Development Control Plan No. 126

Badgee Urban Release Area Sussex Inlet

1. Draft Development Control Plan No. 126 Badgee Urban Release Area Sussex Inlet – Exhibition Outcomes File 47610E (PDR)
-

Figure 3: Precinct Concept Plan showing flood free access road

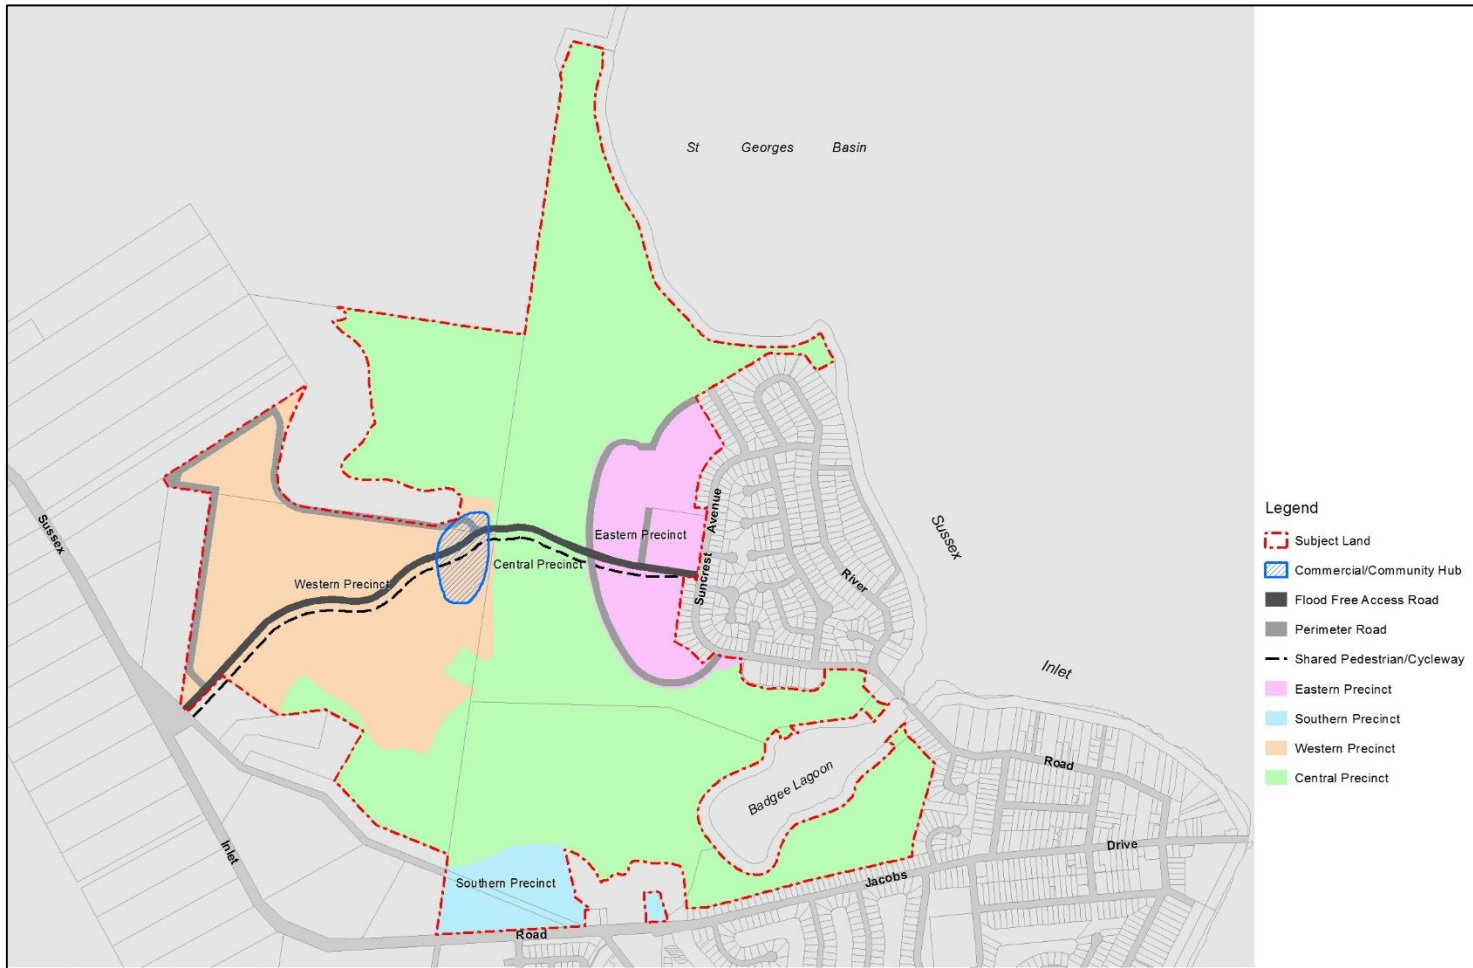
- ii) **Acceptable Solution A1.2 of Section 3.1 Transport Movement Hierarchy include cycle ways to be included in the development application and for the pedestrian pathway shown on the Precinct Concept Plan be identified as a shared pedestrian/cycleway.**

3.1.5 Central Precinct Desired Character (now Section 5.1.4) & Figure 3	<ul style="list-style-type: none"> Reword to note that pathways along FFAR are to be shared pedestrian/cycleways and amend Figure 3 to show shared pedestrian/cycleway Change reference from 'Conservation Management Plan' to 'Environmental Management Plan' (EMP) 	<ul style="list-style-type: none"> Pedestrian pathway shown on the Precinct Concept Plan is now shown as shared pedestrian/cycleway and desired character statement should reflect this as per b)ii) of Development Committee resolution which requires shared pedestrian/cycleway be provided along the Flood Free Access Road Update to terminology – Conservation Management Plans usually relate to heritage conservation rather than management of environmental areas
Section 5, Figure 3	<ul style="list-style-type: none"> Insert amended Figure 3 to show FFAR commencing on the southern side of the existing Council open space area, instead of the northern side 	<ul style="list-style-type: none"> Preliminary assessment of DA SF10425 by Council's Traffic and Transport Unit shows that an intersection on Suncrest Avenue to the northern side of the reserve would require a roundabout to be built due to sight distance issues at that location. As there is adequate sight distance to the southern side of the reserve, the route has been amended to show the FFAR connecting with Suncrest Avenue to the north of Blue Mist Close.

ROUNDABOUT DETAIL SUSSEX INLET RD/GOLFCOURSE WAY
CONCEPT PLAN OF ROUNDABOUT INTERSECTION FROM SUSSEX INLET GOLFCOURSE TO SUSSEX INLET ROAD AT SUSSEX INLET, FOR LUCAS PROPERTY GROUP

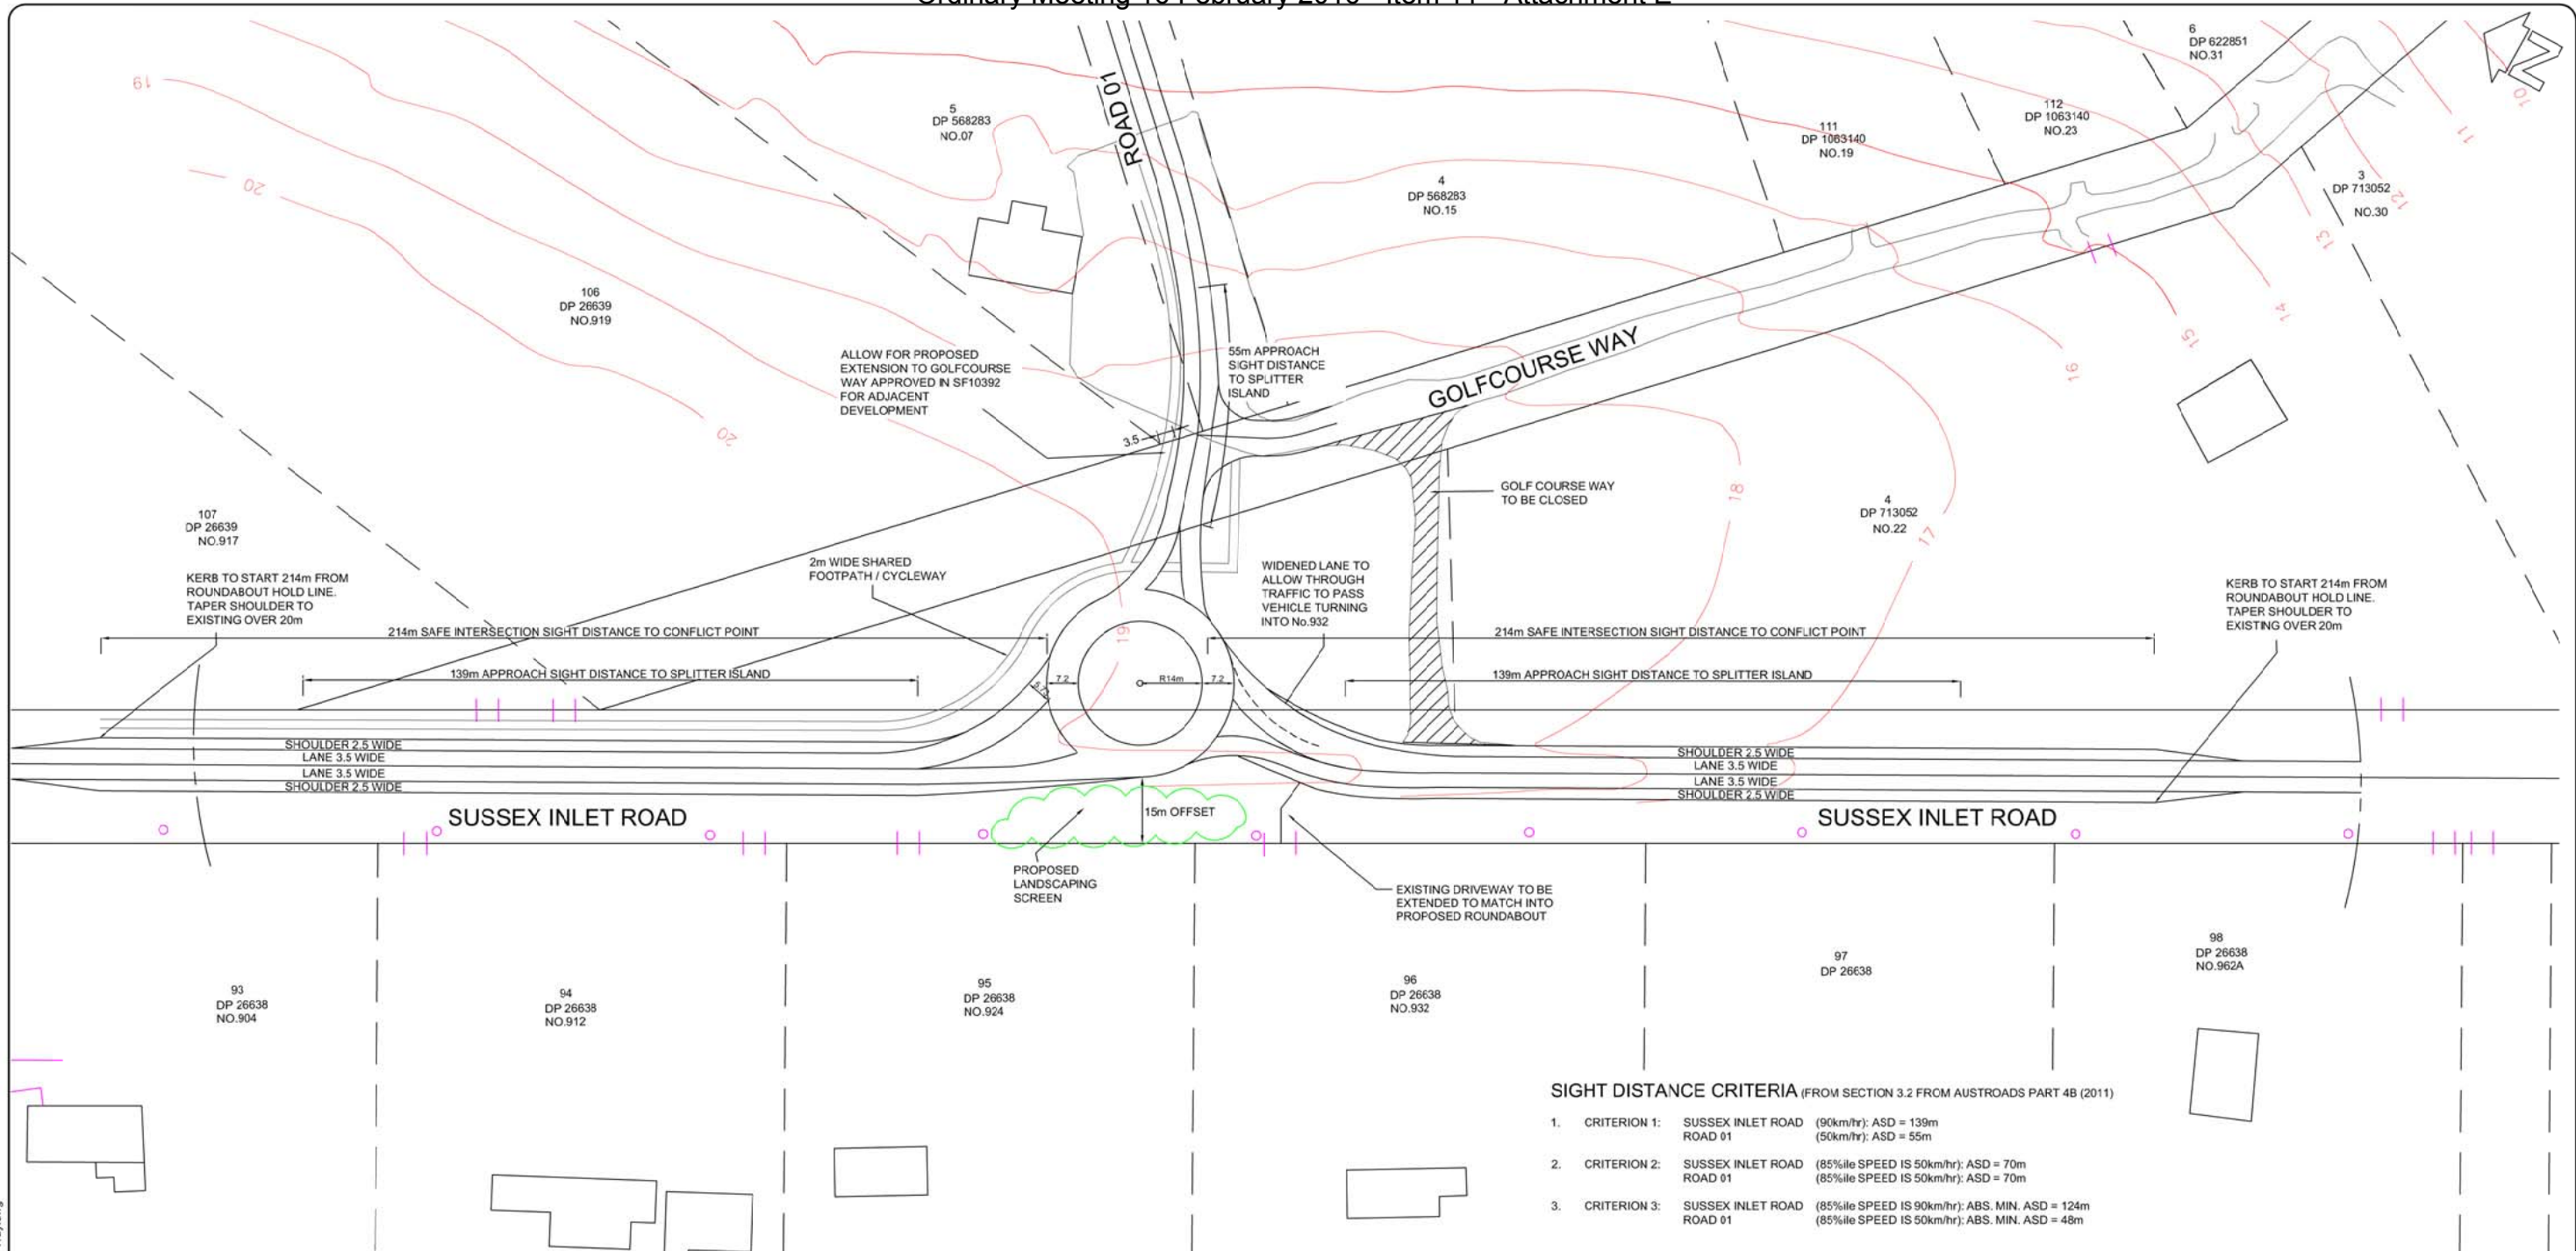
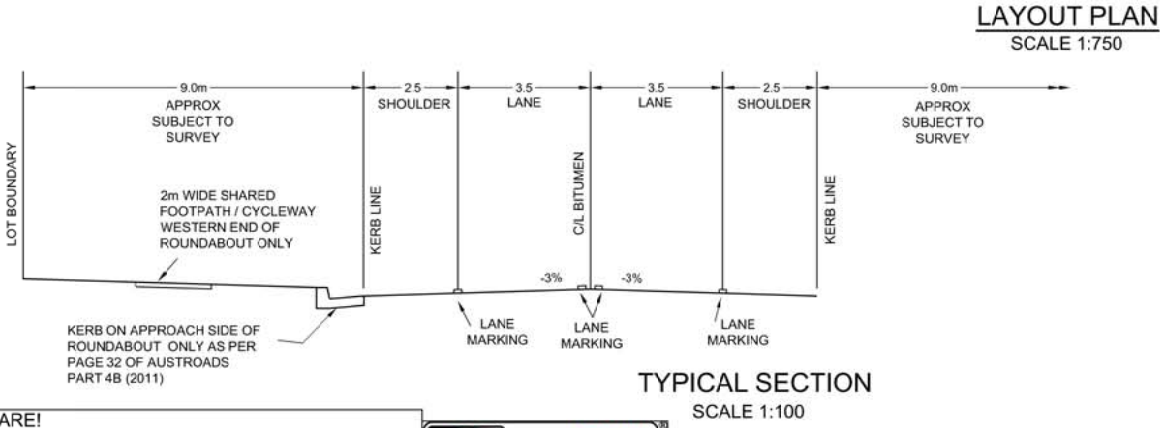
- Concerned about parking for golf course users when the new access road is built, and amenity impacts on her property.
- Looking for more planting along her northern boundary to screen out road and would like it in the road reserve. Concerned about width of roads in URA. Asked what the size of the landscape mound would be and what it will look like.

- Would like roundabout to be moved in location (north-west) closer to Lot 106. Feel that there is still a lot of room within the Council reserve. Also drew on concept plan and showed how Sussex Inlet Road could be made straighter without the deflection that they believe people will not be able to negotiate at the indicated speed.

- Would like to see the area near his property (near the current entrance to Golfcourse Way) vegetated. Concerns that the proposed landscape mound on the concept plan appears small.

- Concerned that there will be overflow car parking for the golf course patrons in the road way area currently marked for closure on the concept plan. [REDACTED] has recently raised these concerns to Councillor Mark Kitchener.

- Concerns about rubbish dumping in this area as already happens a lot with people leaving club throwing bottles out of the window.
- Concerned about extent of additional lighting as a result of the roundabout. Would like sensor lights to be considered (he believes sensor lights were in place opposite Golfcourse Way). As well, would like a mound along his property boundary with vegetation on it. Otherwise has requested that the developer offers him trees to plant along his side of the boundary for screening.

- Traffic Management plan approved during DA process – resident access retained during construction. Golfcourse way would not be closed off until roundabout fully functional. Unsure of when car parking for golf course is to be relocated to, but would be part of DA. Matters like this will be in

- Road 01 into new development is likely to about 6m width along the side of the new road. It will need to provide at least 3m for cars to pull off the road and space for in ground utilities. This may limit planting of trees. Also generally Council is reluctant to do tree planting outside of town centres because plants do not get looked after. However Council can look into this at the detailed design stage. Roads will be a similar width to others in Sussex around 16m-20m in width boundary to boundary, actual road probably needs to be about 9m (2 lanes with 2 way).
- The developer was asked to indicate on new concept plan the lines of vegetation removal but this wasn't done. This information will be included on the detailed design.

- Signage will come after further improvements to the design later down the track – signs and lines plans go through the traffic committee
- FFAR can't go through end of Golfcourse Way because of environmental considerations. OEH has approved provision of FFAR through central E2 area.

- Council does regular traffic counts in town and at highway it's about 2000-3000 thousand a day vehicle movements of which 4% are trucks.
- Council can try and ask developer to provide vegetation as a condition of consent.
- Landscape mound on plan only concept at this stage. Council does not know size etc until finer details looked at.
- Lighting plans to be developed within detailed design phase. The aim is to minimise lighting impacts.
- Clarified staging of provision of FFAR – would be gated fire trail style until such time as the eastern part of the release area was developed.
